Olin's recommended modifications to USEPA's proposed OCSS seismic Lines following the July 12<sup>th</sup> conference Call

### Olin's New Proposed Lines

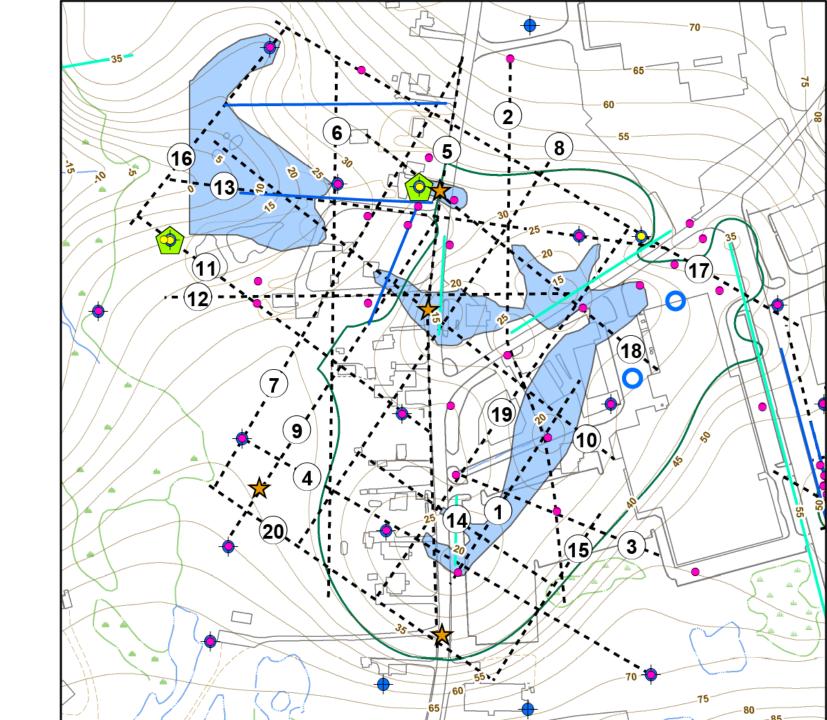
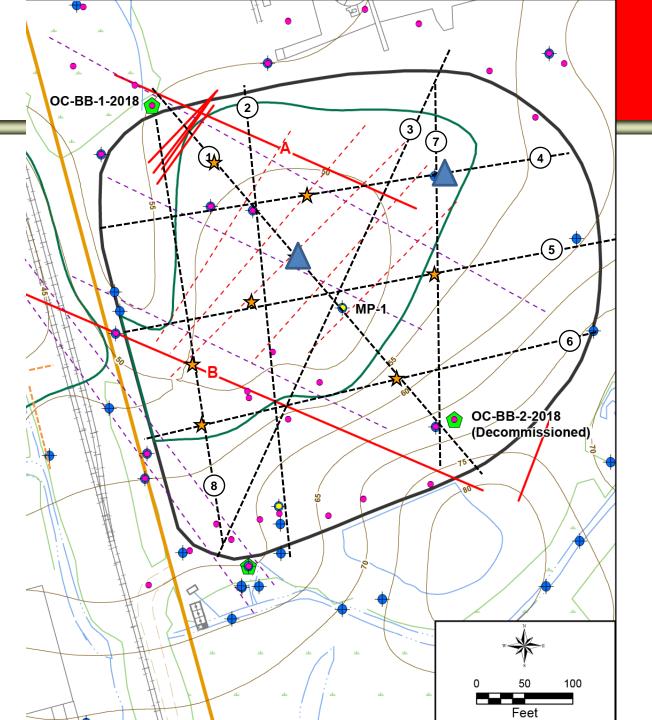
These take into consideration structural impediments

#### Olin's Proposal

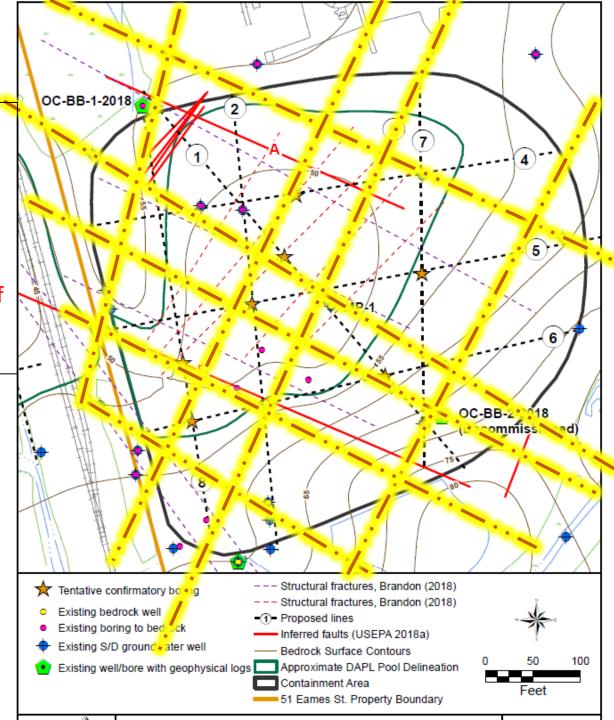
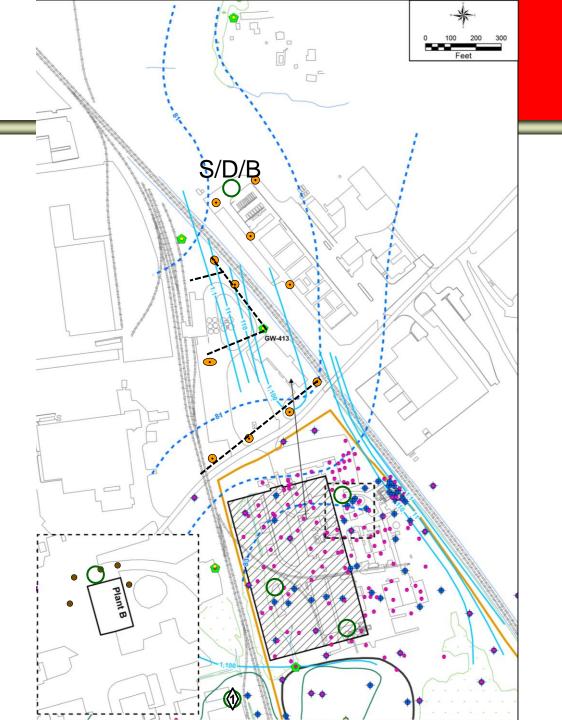
Remove 4 peripheral seismic lines because the sensitivity of the method to detect gaps under the CA wall is unknown. the lines intersecting the wall will provide information to inform a decision on the value of these lines at a future date.

### Jewel Dr. Area OLIN PROPOSAL

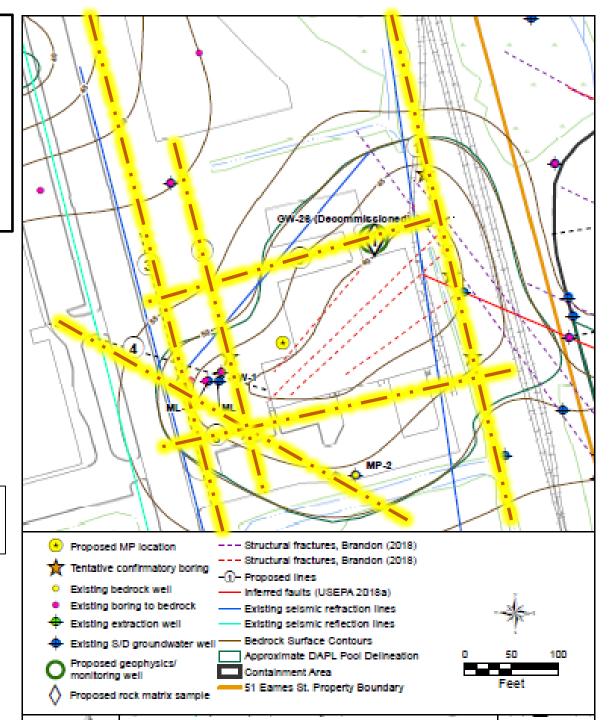
Olin accepts the USEPA suggested lines

## EAST OF OLIN Olin's proposed lines

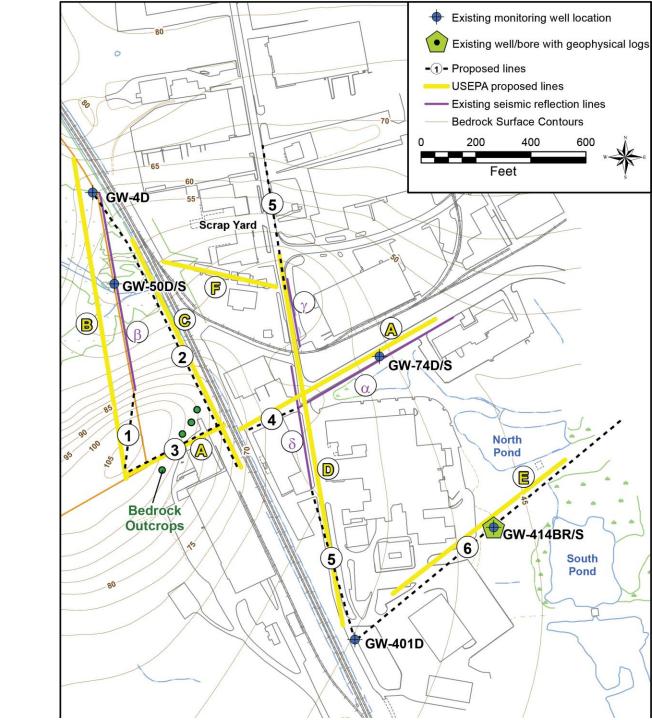
Please see the memo accompanying this Power Point for a detailed explanation of the rationale behind Olin's proposed lines

### MMB AEM SURVEY (OLIN PROPOSAL)

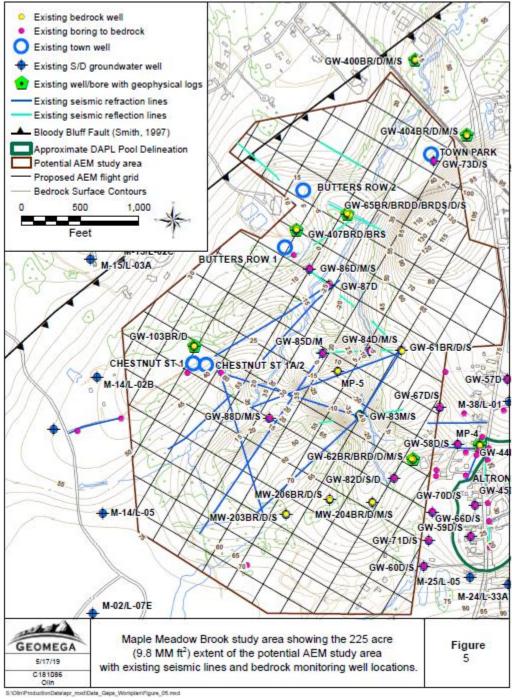
As mentioned on the July 12<sup>th</sup> telephone call, there Are FAA constraints to flying over residences. However, Olin is exploring the possibility of flying around the Wilmington treatment plant to obtain additional coverage to the west and northwest
